# CITY PLANNING COMMISSION

- APPLICATION:**
- A. Negative Declaration
  - B. Rezone of 0.05+ acres from Standard Single Family (R-1) zone to Multiple Family - Review (R-2-R) zone
  - C. Tentative Map to divide 0.85+ partially developed acres into four lots in the R-1 and R-1 zone
  - D. Plan Review of two duplex units on two lots totaling 0.37+ vacant acres in the Multiple Family - Review (R-2-R) zone

**LOCATION:** 4265 65th Street

**PROPOSAL:** The applicant is requesting the necessary entitlements to divide one lot into four lots, two lots for future duplex construction and one lot for future single family unit

**REZONE & BUILDING SITE MAP OF LOT 69, COLONIAL ACRES CITY OF SACRAMENTO, CALIFORNIA JUNE 1989**

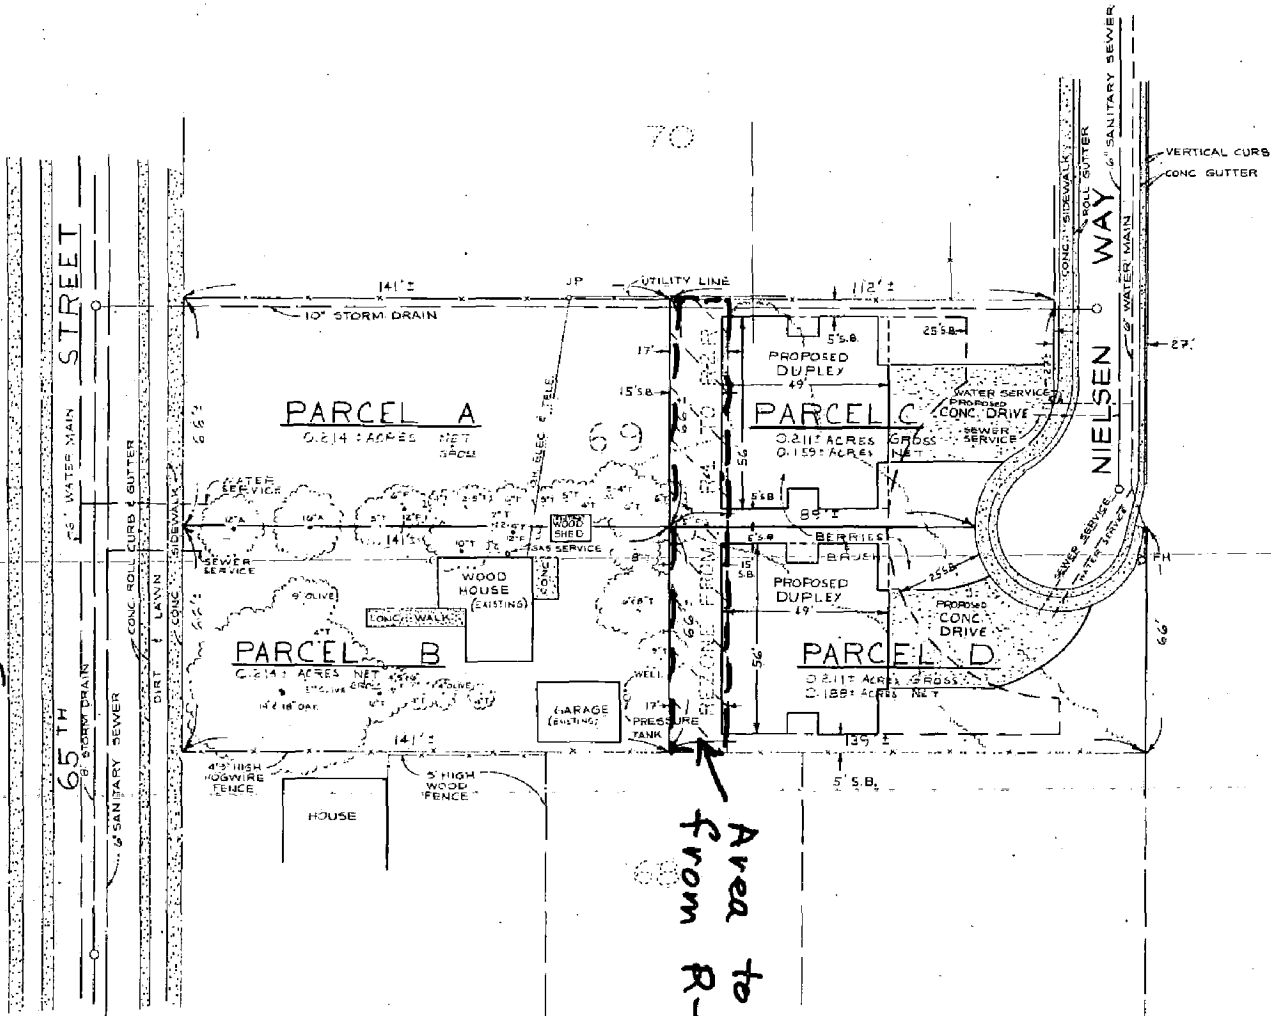
The proposed Tentative Parcel Map establishes lots meeting the minimum standards for residential single family and duplex development. An existing wood shed is to be relocated which is on the property line separating Parcels A and B. Proposed structures meet the minimum building setback requirements and yard requirements. Staff recommends approval of the tentative map subject to conditions.

In order for the zoning for Parcels C and D to be the same and allow adequate rear yard area, an additional 17 feet of R-1 zoned property is needed to be rezoned to R-2-R and added onto the existing R-2-R zoned area. Staff supports the rezoning request since the yard area for the R-2-R zoned lots will be increased and adequate yard area for Parcels A and B will result. In addition, the shape of the existing cul-de-sac has eliminated yard area for Parcels C and D similar to the duplex lots to the north. Therefore, the lot line and zoning must be shifted westerly for 17 feet.

The site is heavily vegetated by blackberry bushes and olive, almond, fruit, oak and various shade trees. All the trees are proposed to be saved; however, five trees are shown to be on the property line between the two lots fronting on 65th Street. To avoid removing any of these trees should a fence ever be constructed along this property line, the following mitigation measure shall apply:

13. Remove refuse and trailer from premises.
14. Property lines shall not divide existing structures (wood shed to be removed or property line changed to go around it).

- A. The property line between proposed Parcel A and Parcel B shall be relocated so that no trees are located directly on the property line.

**FLOOR PLAN**

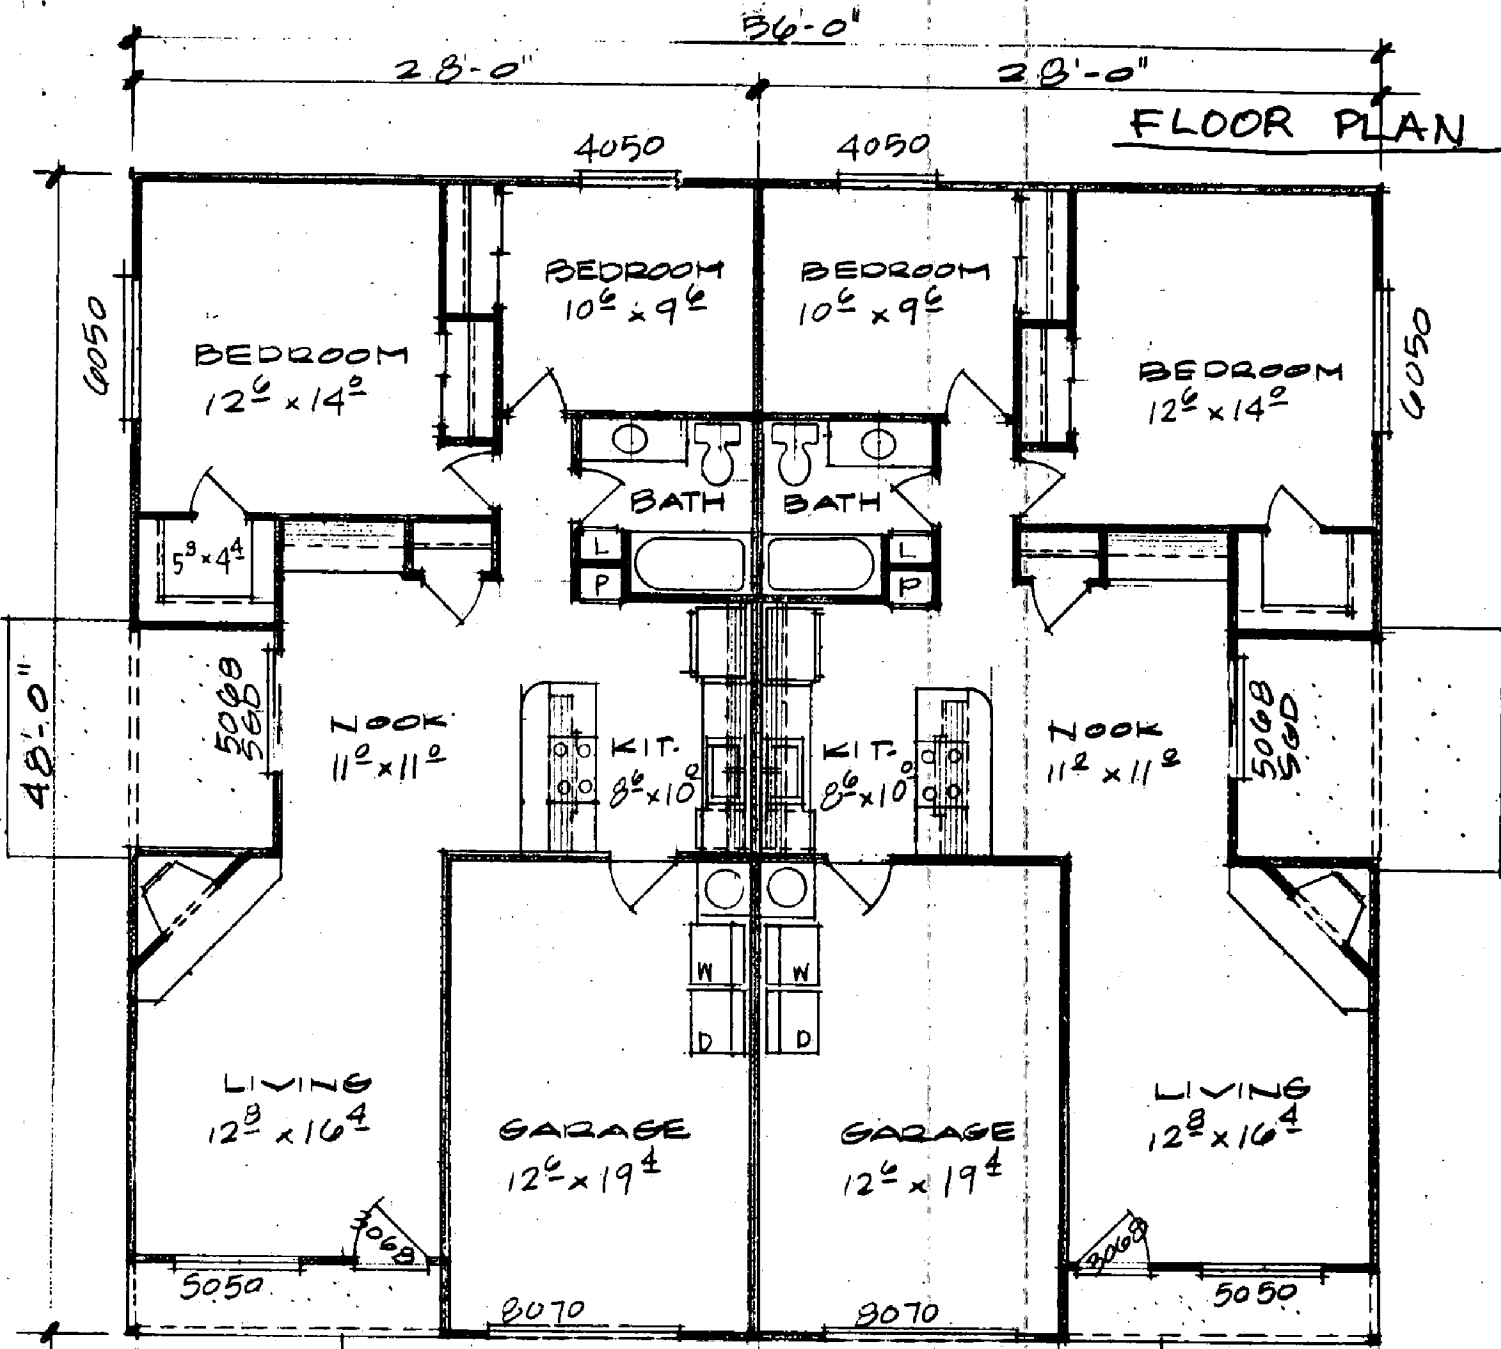
Staff has reviewed the proposed duplex units and find them similar to the existing duplex units located along Nielsen Way. Staff recommends the following changes to the elevations and site plan for the duplex units to provide more variety and attractiveness to the site.

1. The front elevation should contain two or more exterior building materials. Use of a brick veneer or wainscoting below the windows and adjacent to the ground could enhance the elevation. A low decorative masonry wall or berm in the front yard landscape area could also break up the front.

2. Add wood trim elements to all windows and doorways.
3. Show a decorative pattern on the garage doors. Use of small panel windows is suggested.
4. Use two or more exterior materials on the entire building. This could include stucco and plywood siding. Exclusive use of one material is not allowed.

5. For roofing material, use of an earthtone color composition shingle with a minimum 25 year rating.
6. No roof mounted air conditioning equipment is allowed. Heating and cooling equipment is to be ground mounted and screened.

7. Front yard areas are to be landscaped and irrigated for Lots C and D.
8. All rear and side areas are to be fenced with a six foot high solid board fence.

1. The front elevation shall contain two or more exterior building materials. Use of a brick veneer or wainscoting below the windows and adjacent to the ground could enhance the elevation.

2. Add wood trim elements to all windows and doorways.
3. The applicant shall indicate a decorative pattern on the garage doors. Use of small paned windows is suggested.

4. The applicant shall use two or more exterior materials on the entire building. This could include stucco and plywood siding. Exclusive use of one material is not allowed.

5. For roofing material, the applicant shall use an earthtone color dimensional and laminated composition shingle with a minimum 25 year rating.
6. No roof mounted air conditioning equipment shall be allowed. Heating and cooling equipment shall be ground mounted and screened.

7. Front yard areas shall be landscaped and irrigated for Lots C and D.
8. All rear and side yard areas are to be fenced with a six foot high solid board fence.
